STATE OF NORTH CAROLINA DEPARTMENT OF TRANSPORTATION

Addendum No. 1

RE: Contract # C203991 WBS # 45429.3.3 F. A. # STPDA-0540(39) Wake County (U-5315A, U-5315B) Morrisville Parkway Extension From West Of Highcroft Drive To East Of Mills Park Drive In Cary

SIDEWALK PLAN

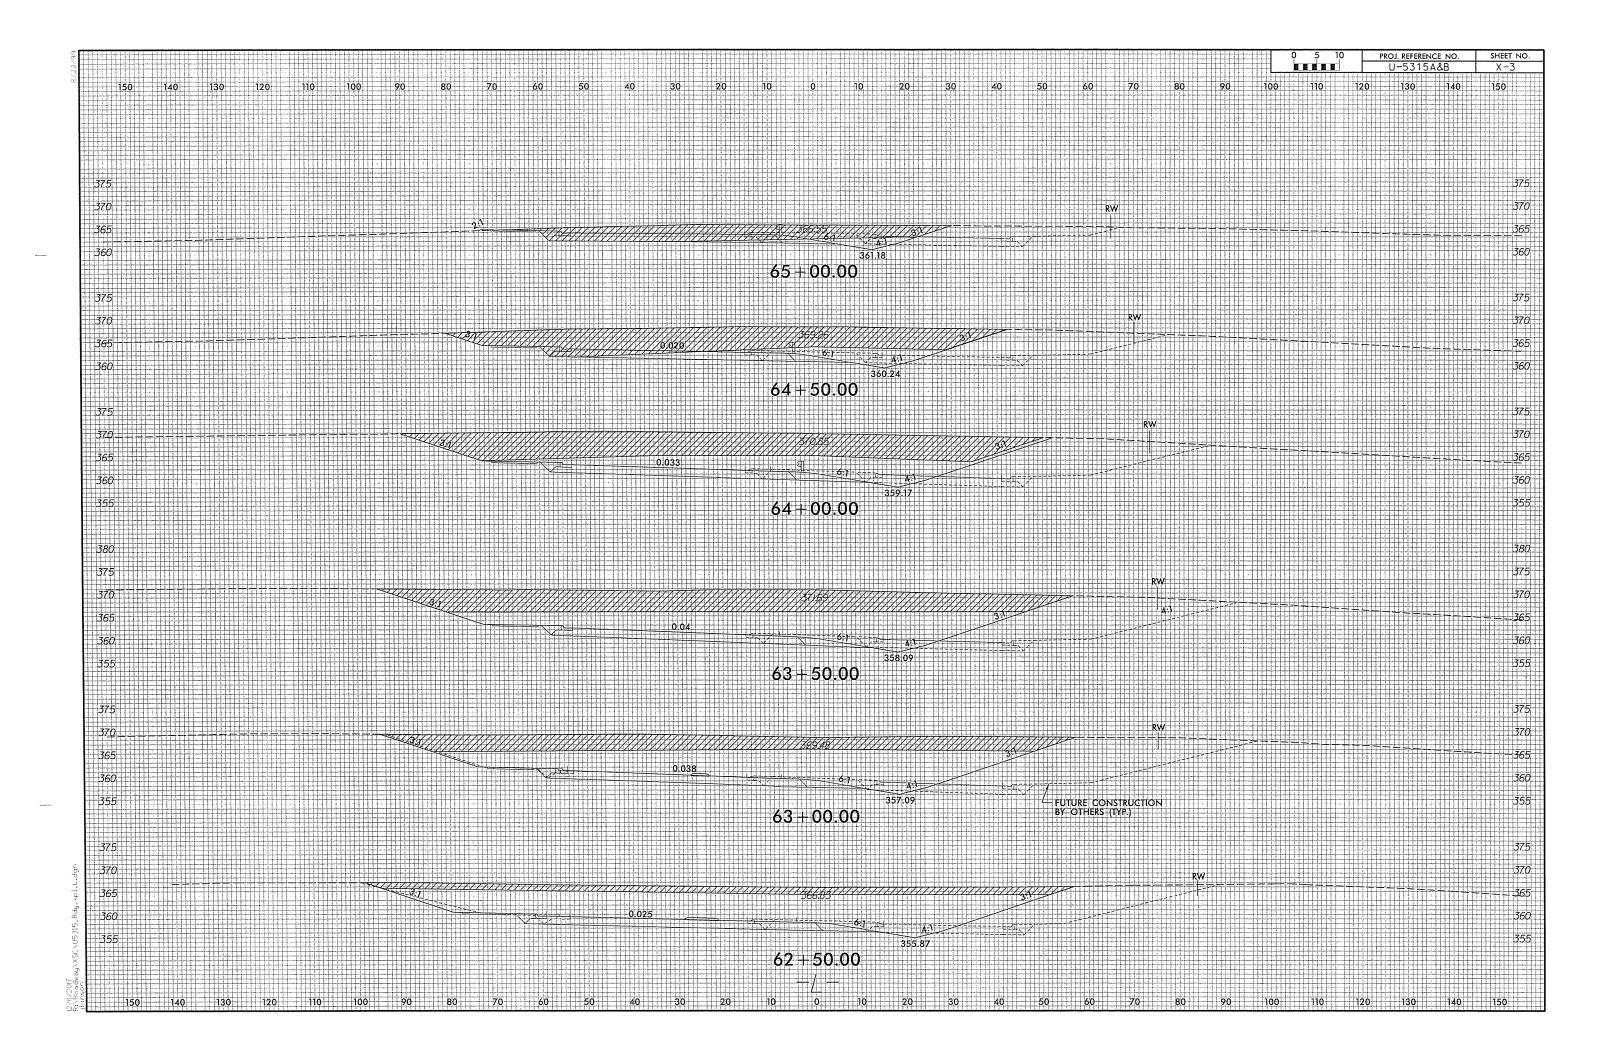
feeder conductors		
ITS-14	Removed splice components for RWIS on splice detail		
X-3	Revised cross-sections for Stations 64+00 thru 65+00 to reflect the		
	change to guardrail from revised Plan Sheet 4		
New S-1 thru S-3	New sheets added to include details/requirements for sidewalk to be		
	constructed on the existing bridge
